RENESAS TECHNICAL UPDATE

Product Category	MPU&MCU		Document No.	TN-R8C-A002B/E	Rev.	2.00
Title	Specification Changes in the R8C/L35A Group, R8C/L35B Group, R8C/L36A Group, R8C/L36B Group, R8C/L38A Group, R8C/L38B Group, R8C/L3AA Group R8C/L3AB Group Hardware Manual		Information Category	Technical Notification		
Applicable Products	R8C/L35A Group, R8C/L35B Group R8C/L36A Group, R8C/L36B Group R8C/L38A Group, R8C/L38B Group R8C/L3AA Group and R8C/L3AB Group	Lot No.	Reference Document	Described below

Figure 2-1.High-Speed On-Chip Oscillator Control Register 0 (FRA0) Setting

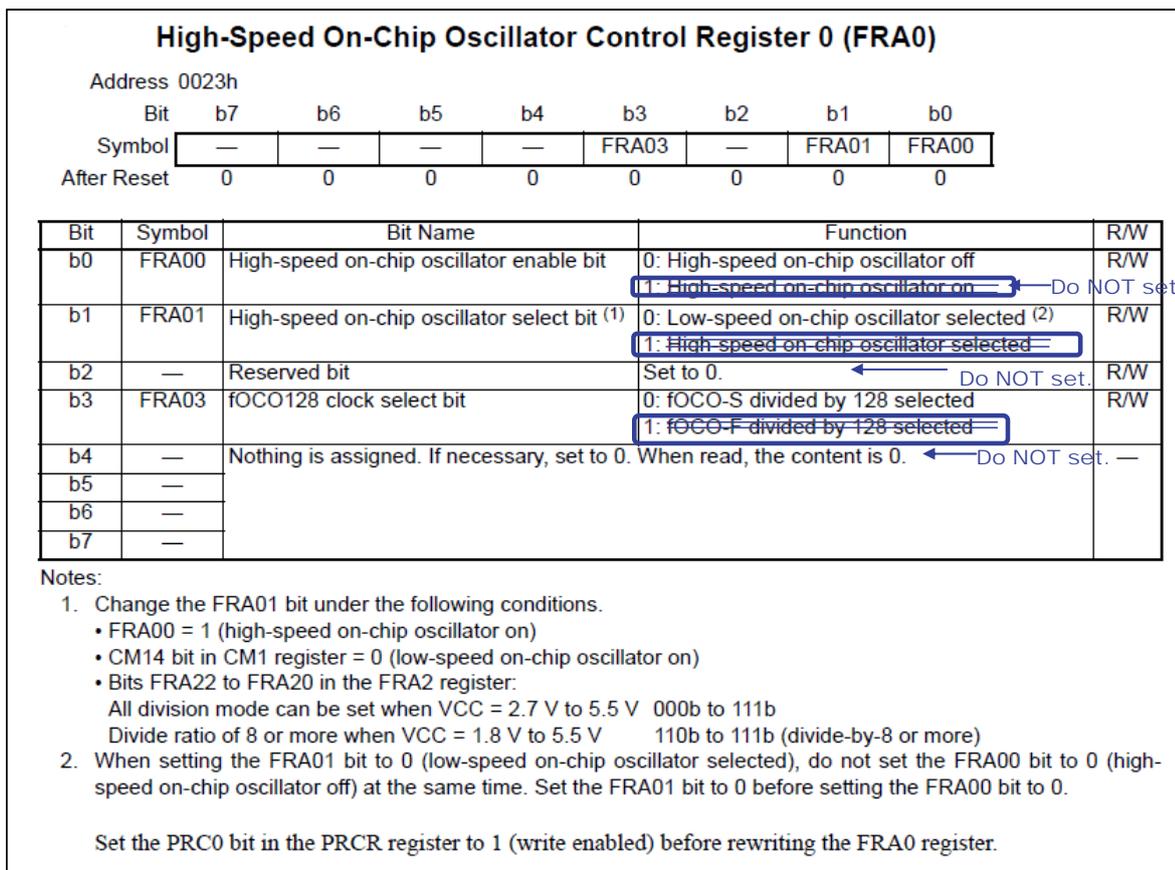
- (1) Do NOT set FRA00 bit to 1 (high-speed on-chip oscillator on) [refer to Figure 2-1]
- (2) Do NOT set FRA01 bit to 1 (high-speed on-chip oscillator selected as fOCO clock source) [refer to Figure 2-1].
The fOCO is a clock source of timer RA.
- (3) Do NOT set FRA03 bit to 1 (fOCO-F divided by 128 selected as a clock source of fOCO128) [refer to Figure 2-1].
fOCO128 is used as an input-capture signal of timers RC and RD.

- (1) Do NOT set the FRA01 bit to 1 (high-speed on-chip oscillator selected for the fOCO clock) [refer to Figure 2-1]. The high-speed on-chip oscillator clock cannot be selected as the timer RA count source.

- (1) Do NOT set the FRA03 bit to 1 (fOCO-F divided by 128 selected as the fOCO 128 clock) [refer to Figure 2-1]. For the timer RC input-capture function, fOCO-F divided by 128 cannot be selected for the input-capture trigger input of the TRCGRA register.

- (1) Do NOT set the FRA03 bit to 1 (fOCO-F divided by 128 cannot be selected for the input-capture trigger input of the TRDGRA0 register [refer to Figure 2-1]. For the timer RD input-capture function, fOCO-F divided by 128 cannot be selected for the input-capture trigger input of the TRDGRA register.

Figure 2-3. Timer RC Control Register 1 (TRCCR1) Setting

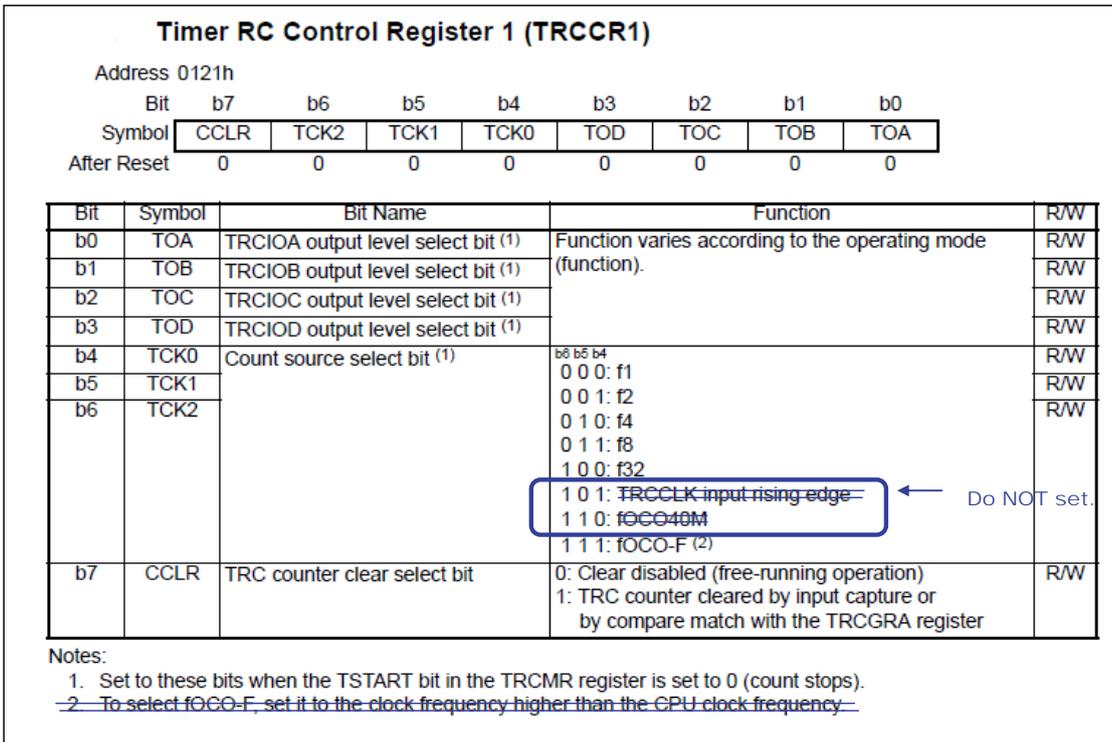
- (1) Do NOT set bits TCK2 to TCK0 to 110b (fOCO40M selected as the timer RC count source) [refer to Figure 2-3].
- (2) Do NOT set bits TCK2 to TCK0 to 111b (fOCO-F selected as the timer RC count source) [refer to Figure 2-3].

Figure 2-4. Timer RD Control Register 0,1 (TRDCR0, TRDCR1) Setting

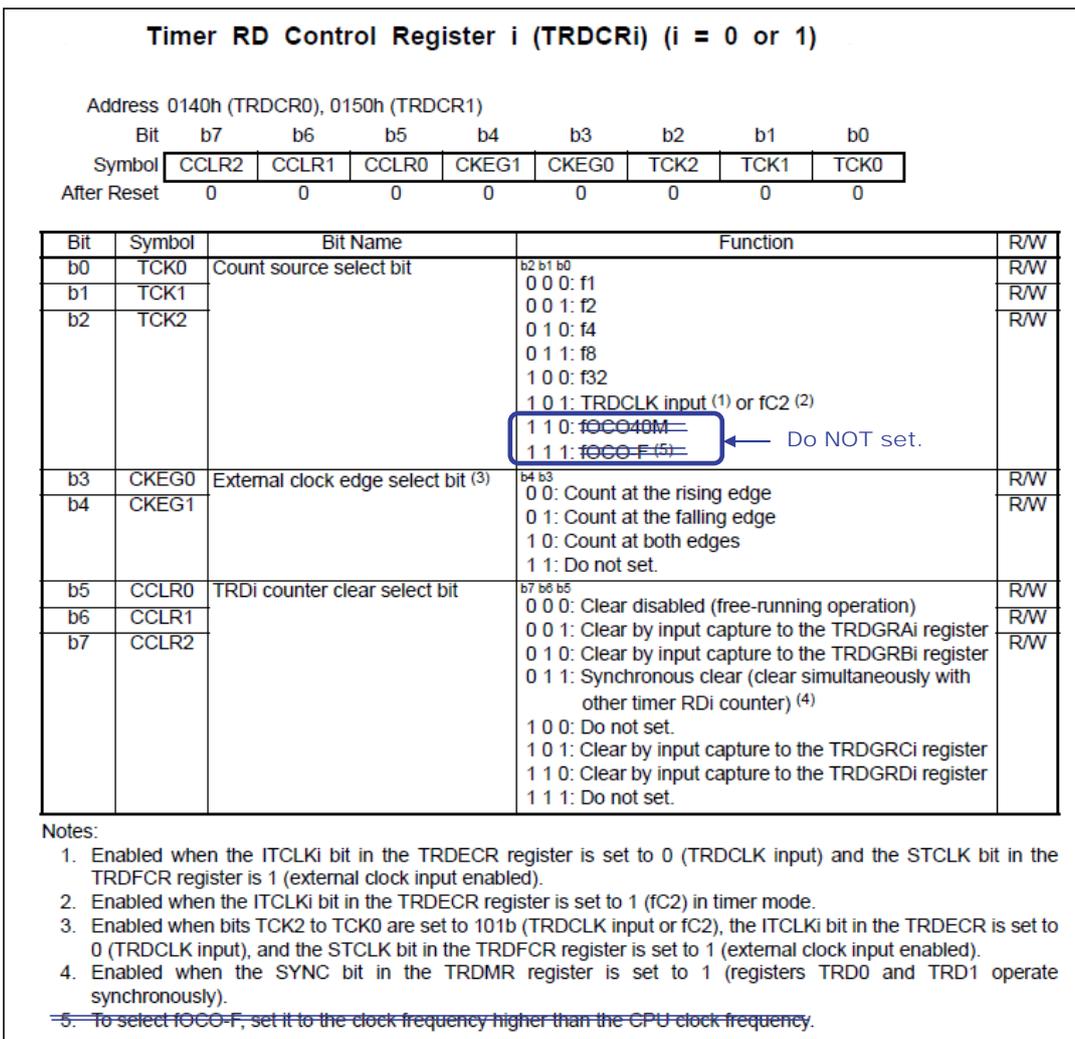
- (1) Do NOT set bits TCK2 to TCK0 to 110b (fOCO40M selected as the timer RD count source) [refer to Figure 2-4].
- (2) Do NOT set bits TCK2 to TCK0 to 111b (fOCO-F selected as the timer RD count source) [refer to Figure 2-4].

Figure 2-5. Timer RG Control Register (TRGCR) Setting

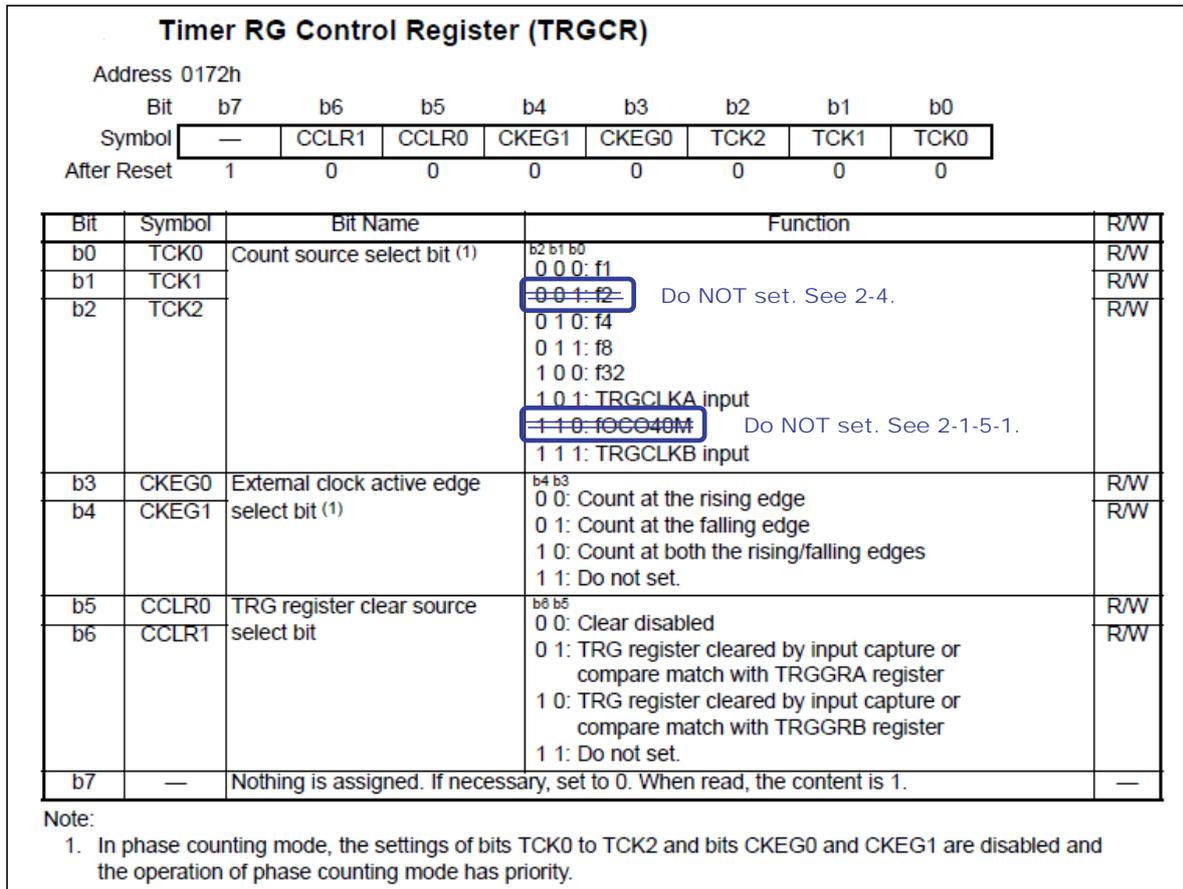
(1) Do NOT set bits TCK2 to TCK0, the count source select bits in the timer RG control register (TRGCR), to 110b (fOCO40M selected as a count source of timer RG) [refer to Figure 2-5].

Do NOT set the count source select bits (TCK2 to TCK0) in the timer RG control register (TRGCR) to 001b (f2 selected as the count source of timer RG) [refer to Figure 2-5].

Figure 2-6. A/D Mode Register (ADMOD) Setting

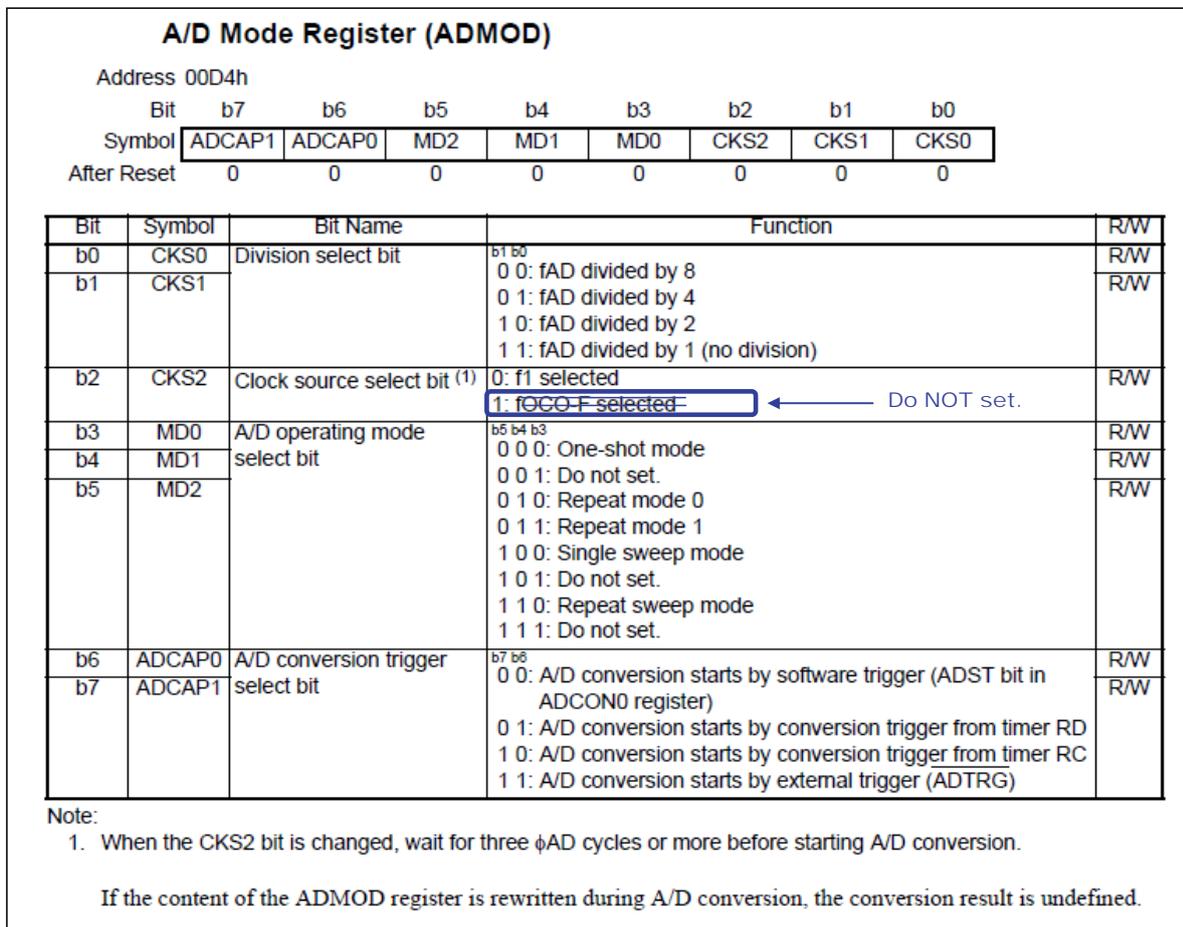
(1) Do NOT set the CKS2 bit to 1 (fOCO-F selected as the A/D converter operating clock source) [refer to Figure 2-6].
